## S4.55 Proposed Changes

### 54-58 Beaconsfield Street, Newport:

#### 4. Addition of Skylights to unit 201/203/204/205

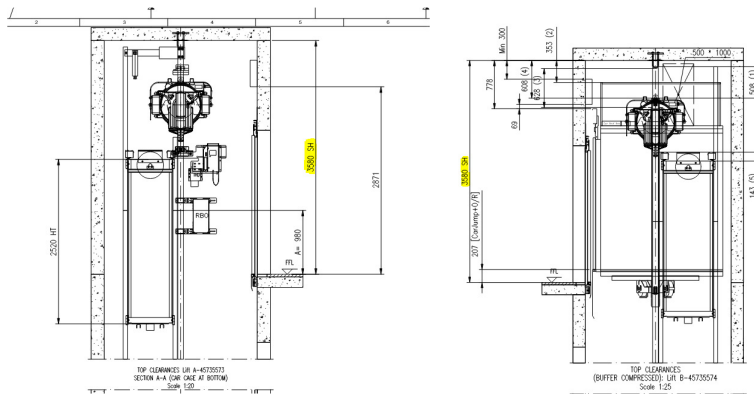
Additional skylights were added to improve the living room amenity, strategically locating skylights above living and kitchen spaces to accentuate the access to daylighting of these spaces.

**SLIDING DOOR STEP DOWN OVERALL DETAIL**  
1:5

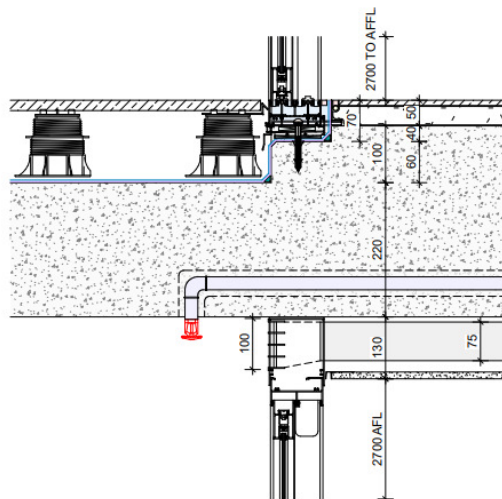
6. Floor to floor height increased.

Both Re:Street, the developer and the Consultant team are seeking to achieve a premium outcome for its end users, which includes detailed design to provide a flush transition from internal to balcony and communal spaces whilst still maintaining 2.7m clear to all habitable areas. For this detail to be achieved, the structural slab is required to be set down to the external areas which requires further increases to the floor-to-floor heights. Secondly, the to Refer to the detail design below which demonstrates 3200mm from Ground to Level 01, and level 01 to level 02 achieves 2700mm ceiling height. The additions 100mm for Level 02 to Roof is required for the insulative requirements to achieved under the BASIX requirements to all exposed roof spaces.
